POWER AUTHORITY OF THE STATE OF NEW YORK

Subject: James A. FitzPatrick Nuclear Power Plant
Docket No. 50-333
Response to NRC April 22, 1980 Letter
Concerning Spent Fuel Pool (SFP) Cooling

RESPONSE TO ENCLOSURE (1) OF THE NRC LETTER OF APRIL 22, 1980

ATTACHMENT 1
Schematic Arrangement of Interconnection between RHR and SFPC Systems

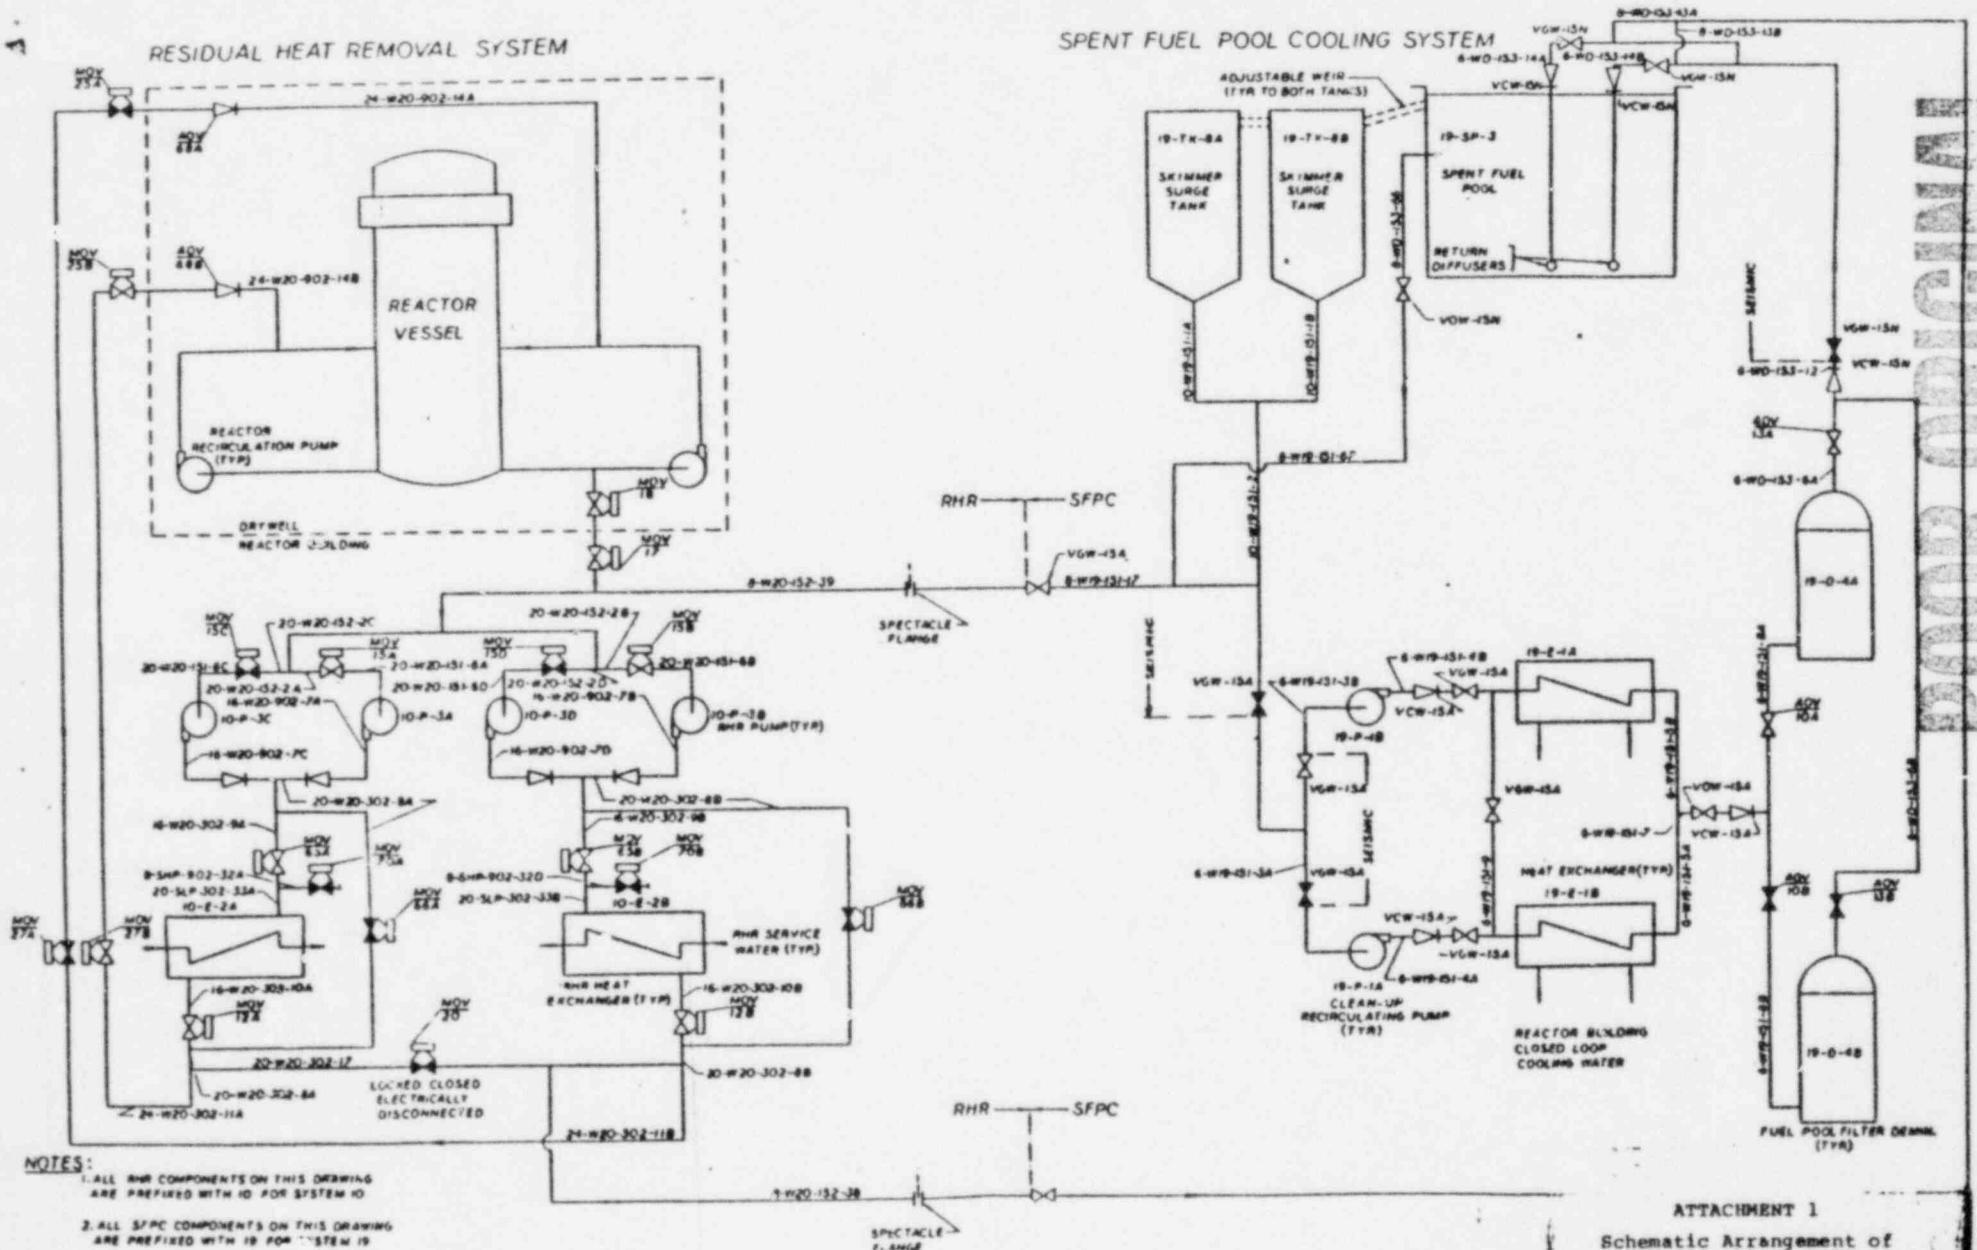
Following a Safe Shutdown Earthquake (SSE), what components, systems or subsystems of pool cooling systems remain available? For those items assumed available, please provide design details such as the stress analysis, hydraulic analysis and applicable codes and standards used in the design procurement and installation. (In the event availability is time dependent, please provide justification for system line-up changes as they effect redundant reactor core cooling capability).

Please provide similar information as requested in item (1) above assuming loss of off-site power.

RHR cooling of the spent fuel pool can be accomplished with out interfering with RHR cooling of the reactor. Attachment 1 shows the interconnections between the RHR and SFPC systems. It is also expected that, for Case 2, cycling between the RHR shutdown cooling mode and SFP cooling would be feasible.

In the event of a loss of off-site power, the RHR system would again be required to provide cooling of the Spent Fuel Pool using the same line-up as presented in response to Item 1.

ATTACHMENT 1
Schematic Arrangement of
Interconnection between
RHR and SFPC Systems

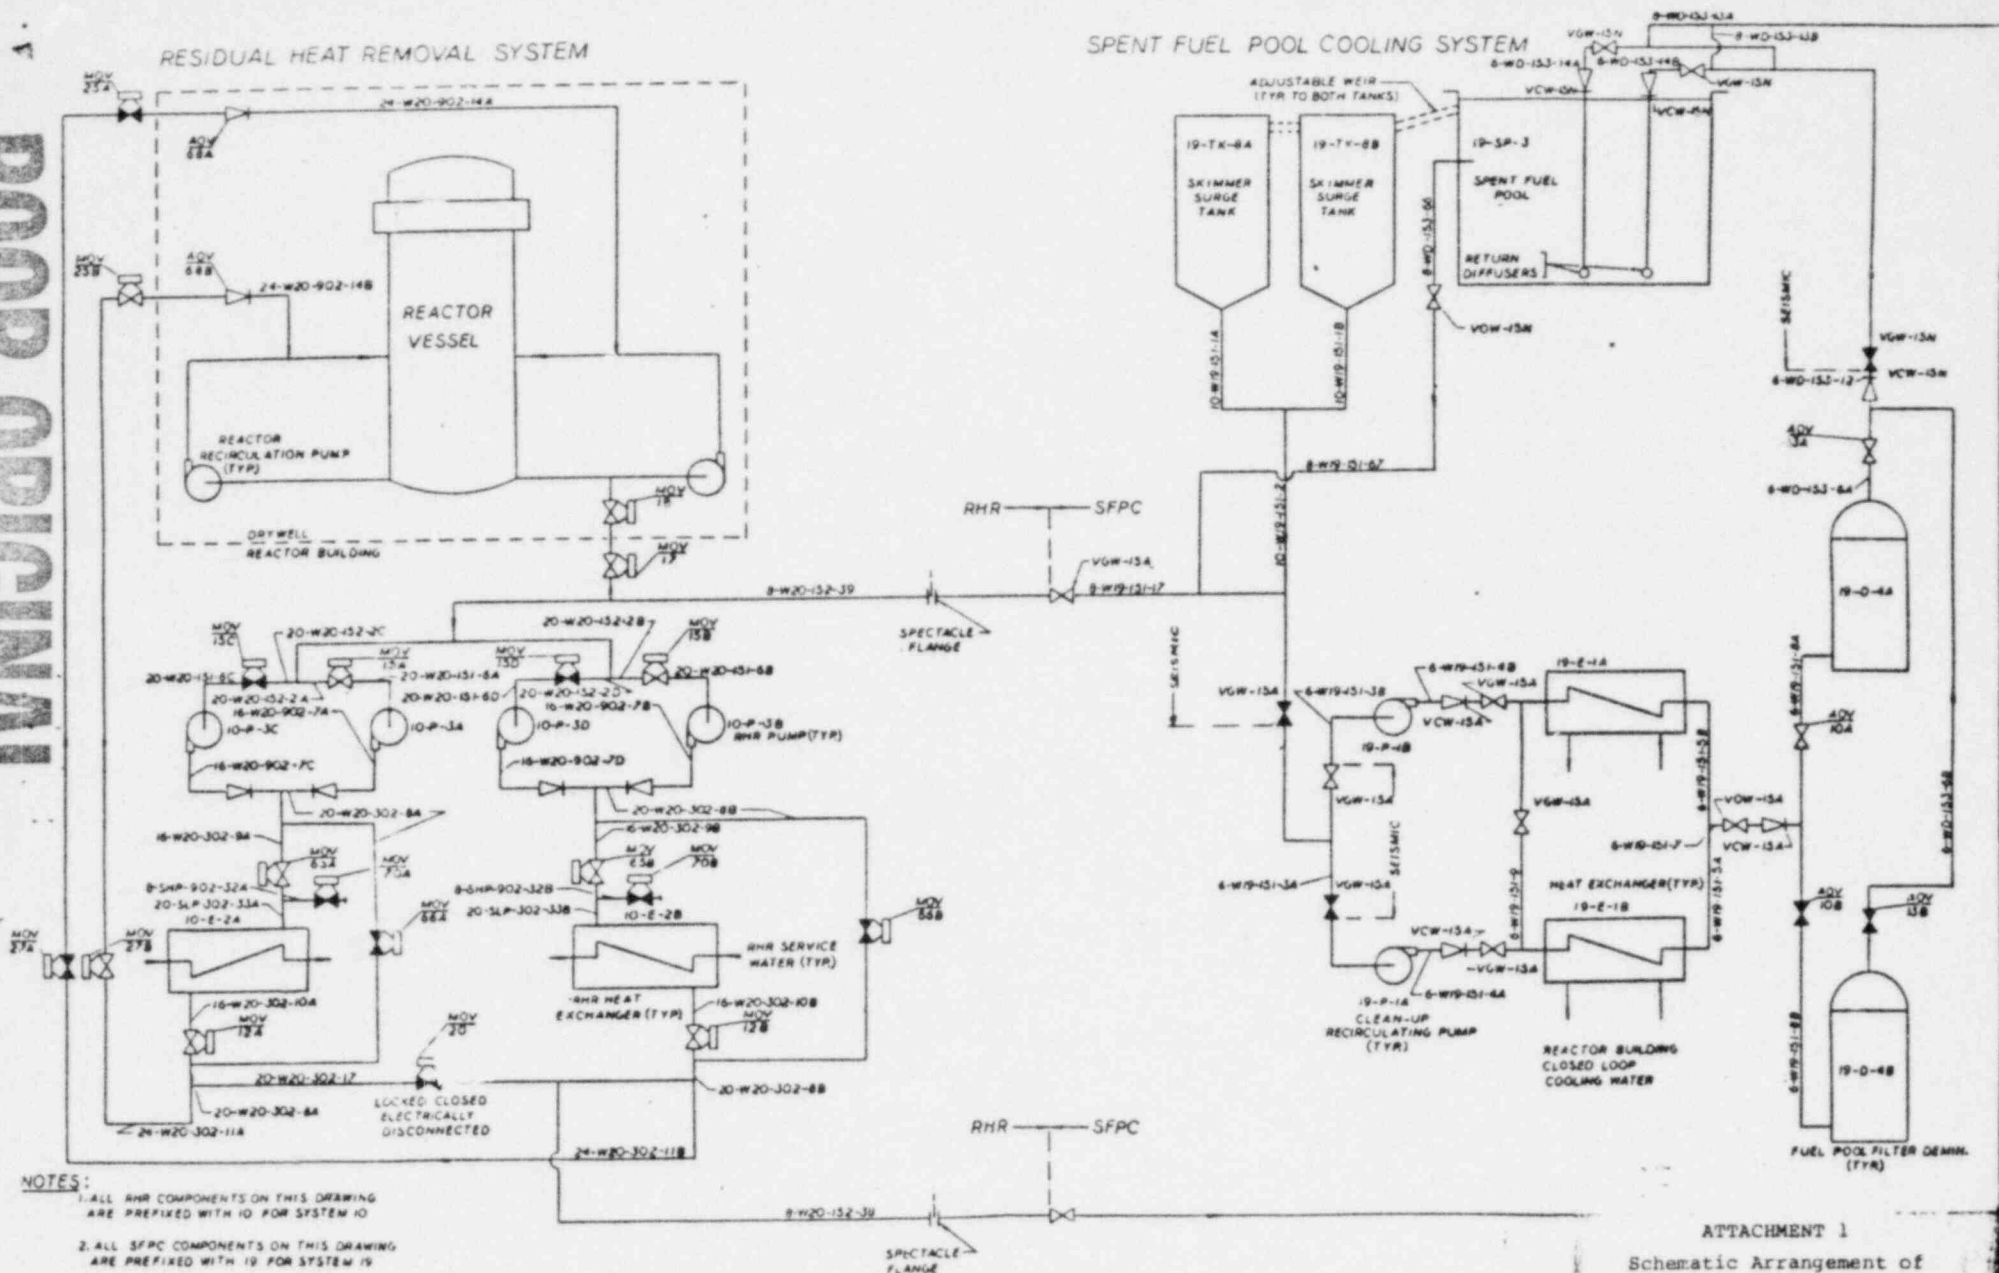
Following a Safe Shutdown Earthquake (SSE), what components, systems or subsystems of pool cooling systems remain available? For those items assumed available, please provide design details such as the stress analysis, hydraulic analysis and applicable codes and standards used in the design procurement and installation. (In the event availability is time dependent, please provide justification for system line-up changes as they effect redundant reactor core cooling capability).

Please provide similar information as requested in item (1) above assuming loss of off-site power.

RHR cooling of the spent fuel pool can be accomplished without interfering with RHR cooling of the reactor. Attachment 1 shows the interconnections between the RHR and SFPC systems. It is also expected that, for Case 2, cycling between the RHR shutdown cooling mode and SFP cooling would be feasible.

In the event of a loss of off-site power, the RHR system would again be required to provide cooling of the Spent Fuel Pool using the same line-up as presented in response to Item 1.
